FOR PERCOLATION TESTING AND SITE EVALUATION

Re: Percolation Testing Results
6396 Guilford Road
Tax Map: 35 Parcel: 305

Attached is the site plan you requested for the Lohaus Property, (Permit #00156957) with the data you recorded on January 24, 2006.

Attached is a revised site plan you requested for the Lohaus Property, (Permit #00156957) .

HOLE PROXIMITIES

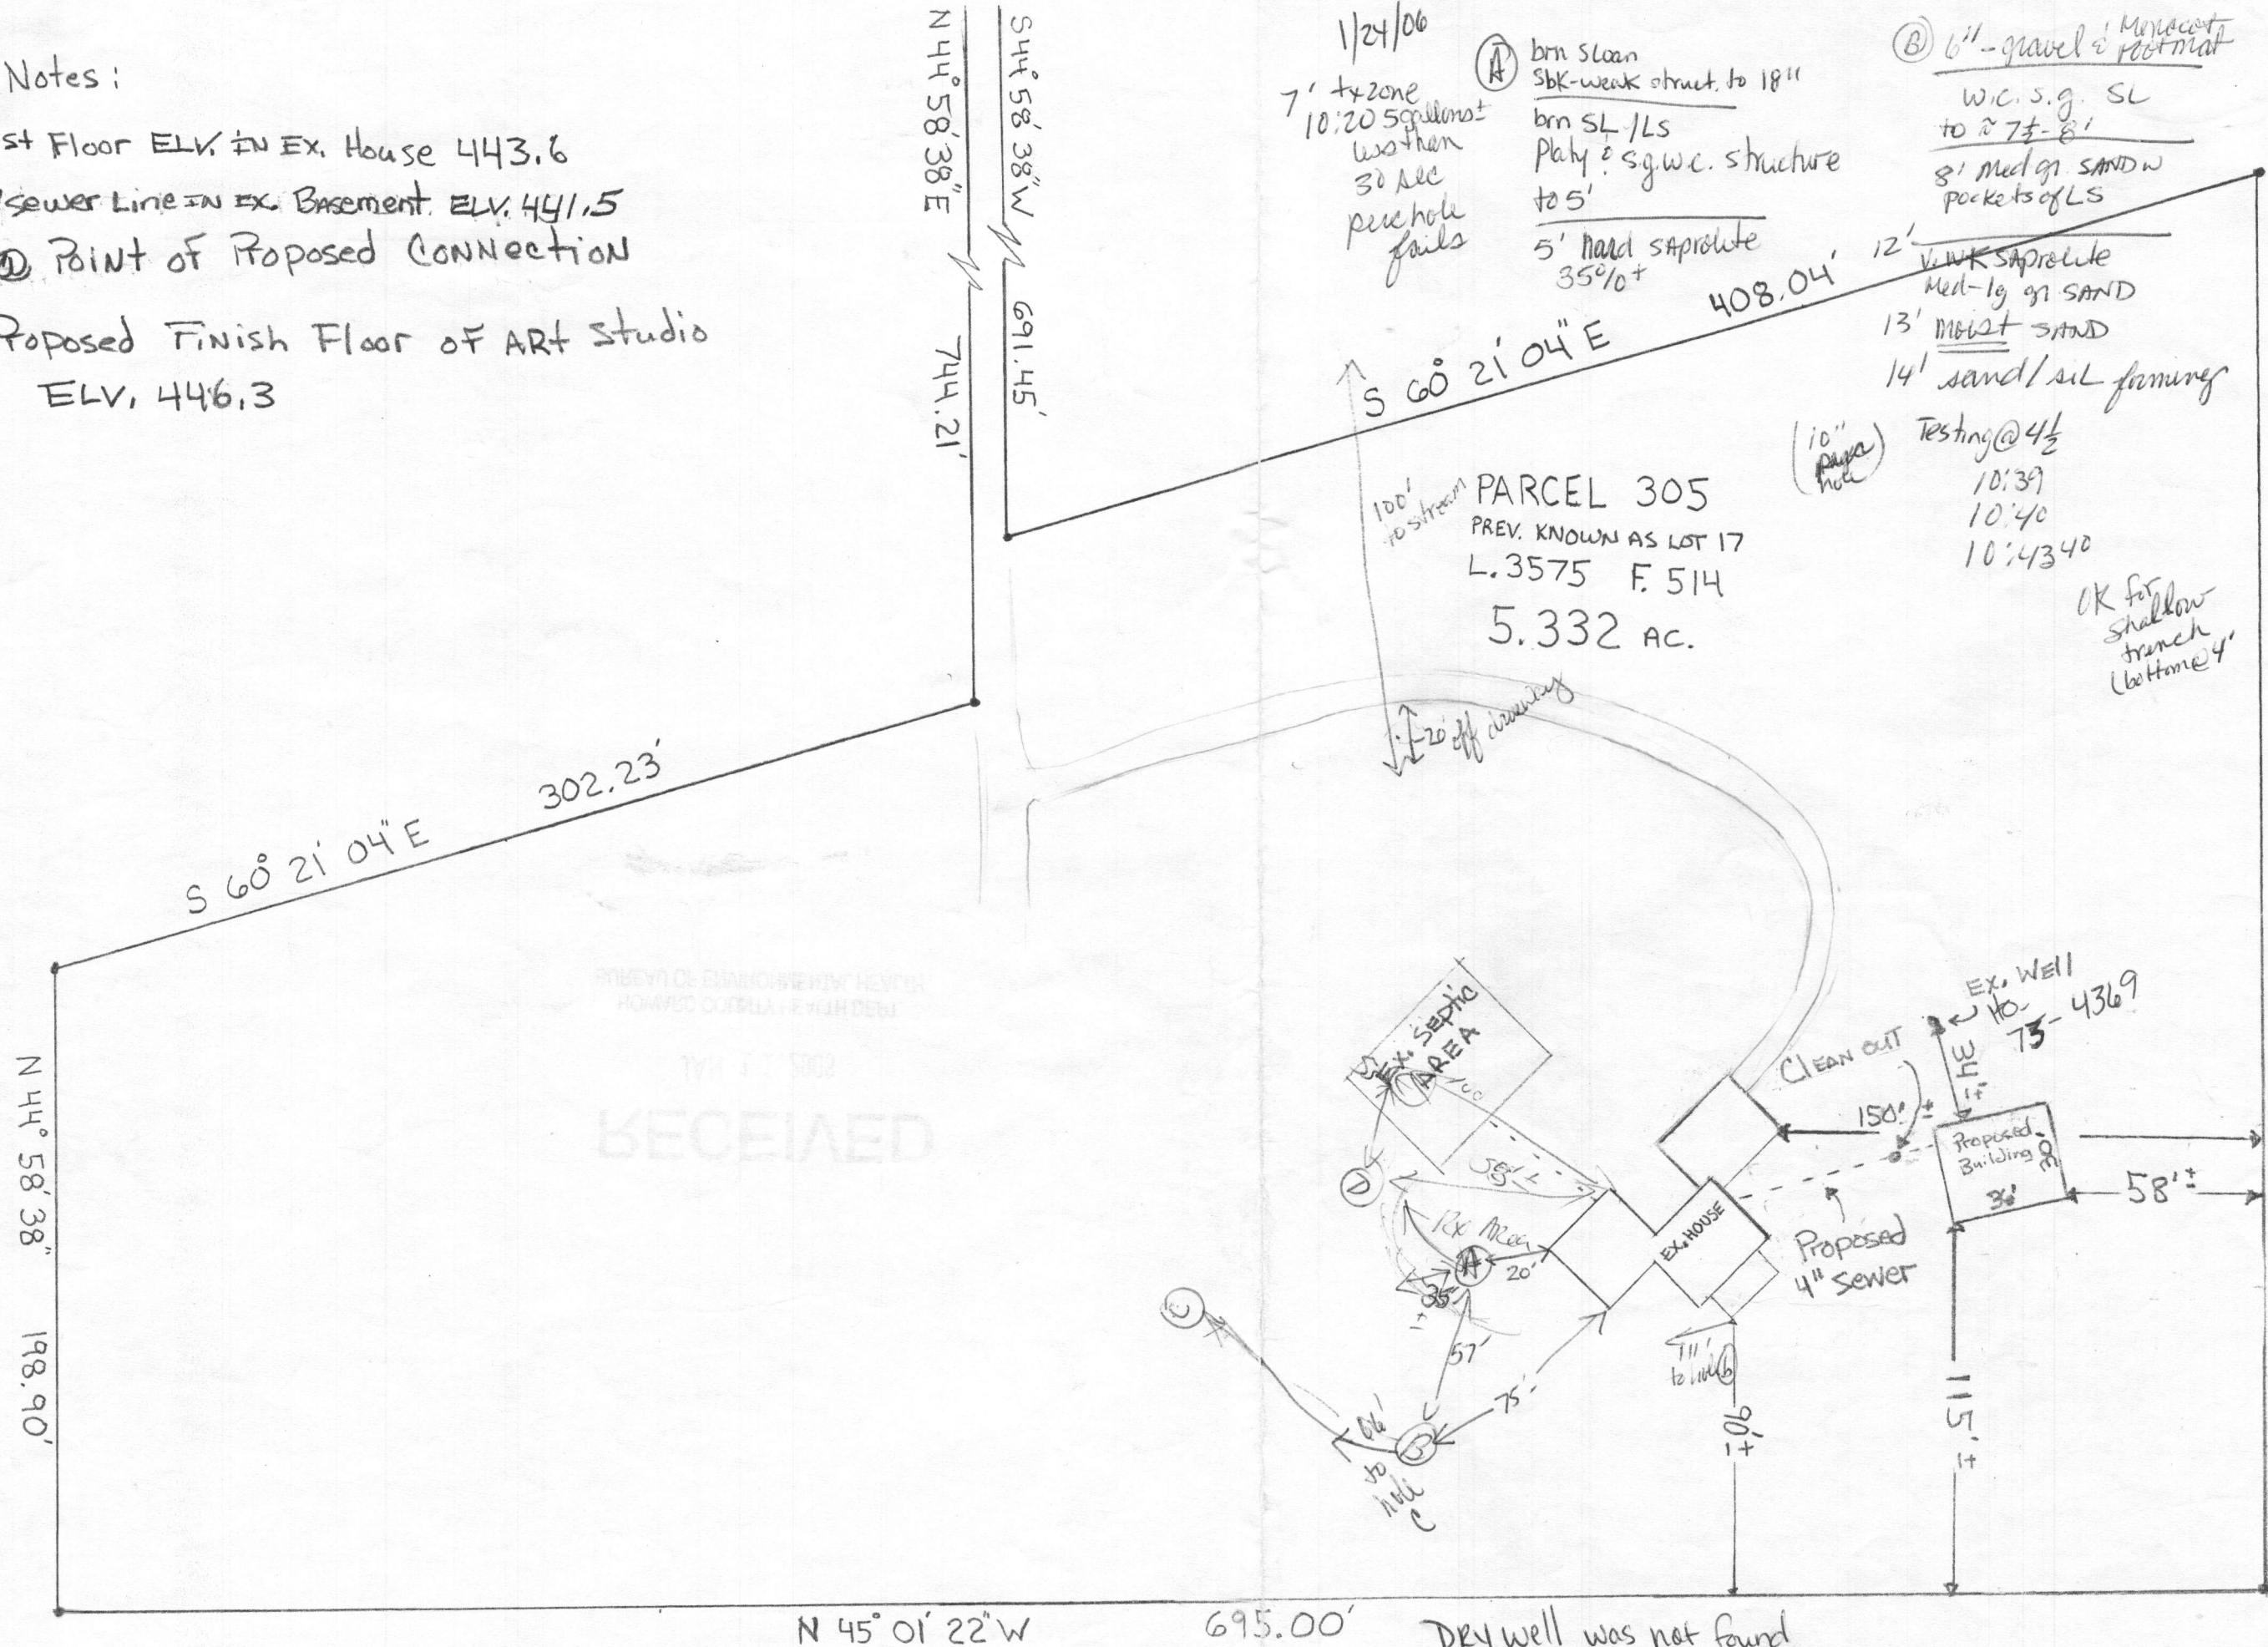
TO
HIDE
E 55' from
"D" and 100'
off house
corner

HOLE D APPROX 40' NE OF HOLE A

MOIST SOILS @ 121

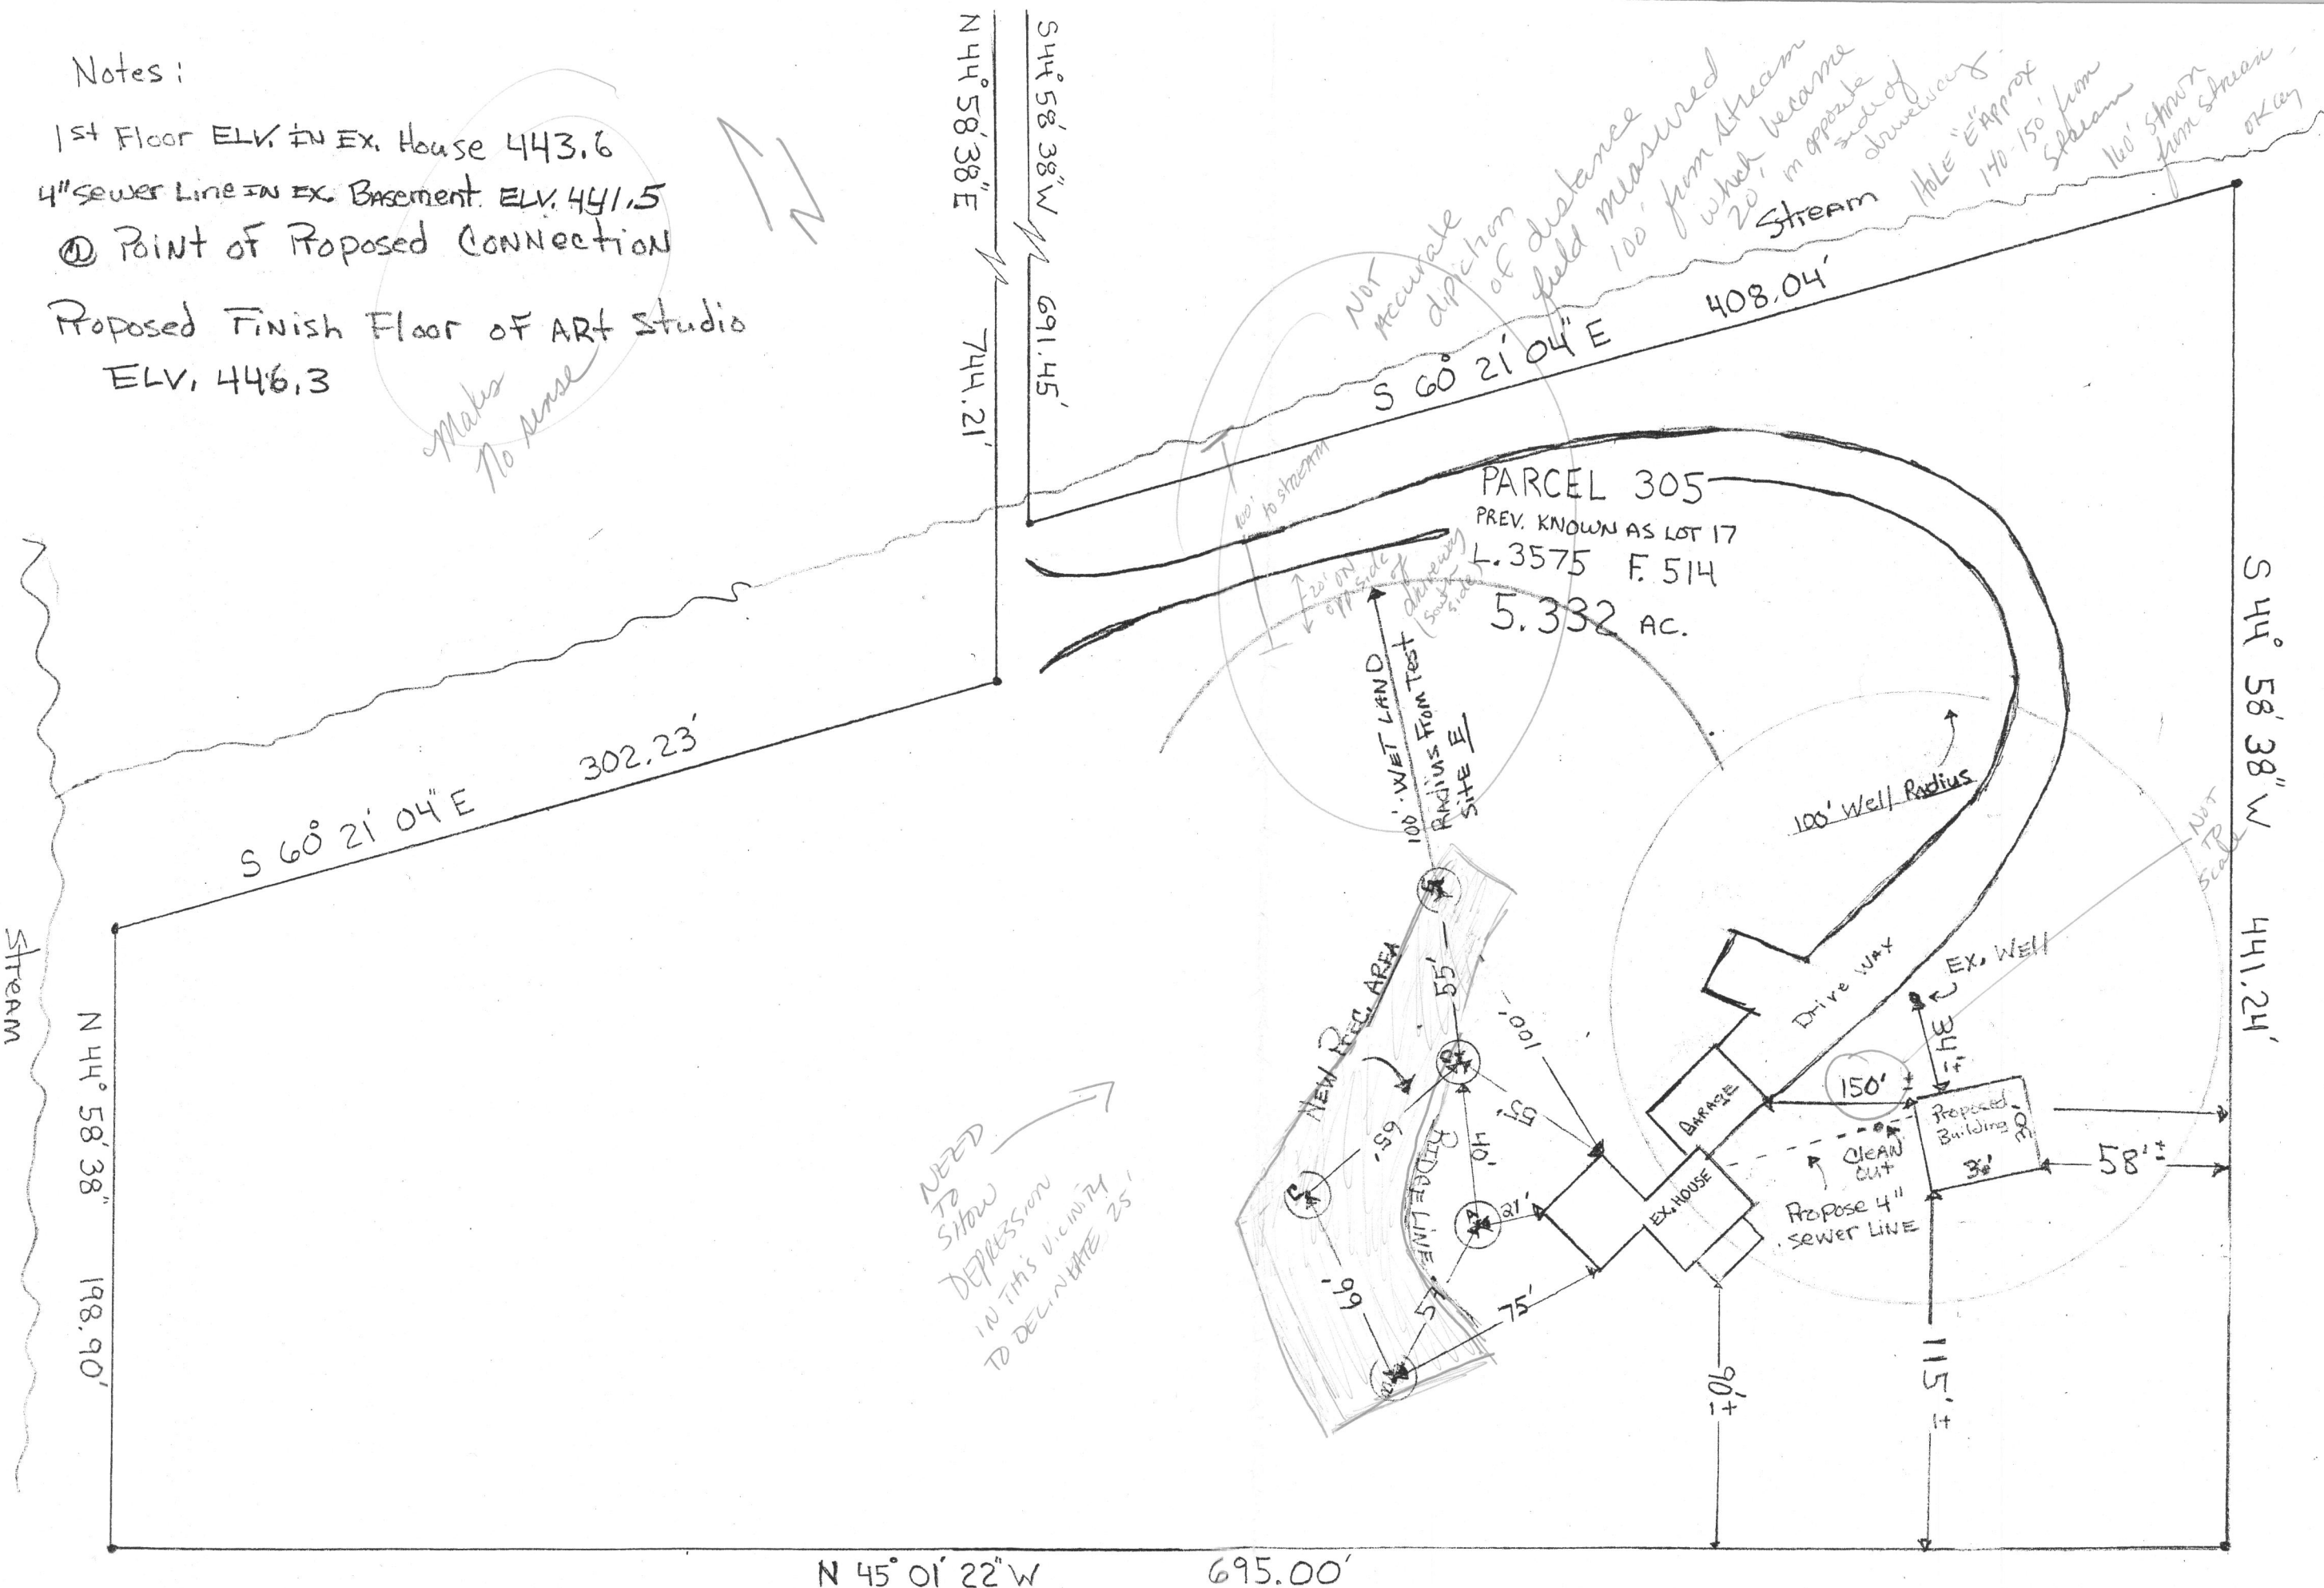
Makes No sense

Not accurate depiction of distance field measured 100' from stream what became 20' in opposite side of driveway

NEED TO SHOW DEPRESSION IN THIS VICINITY TO DELINEATE
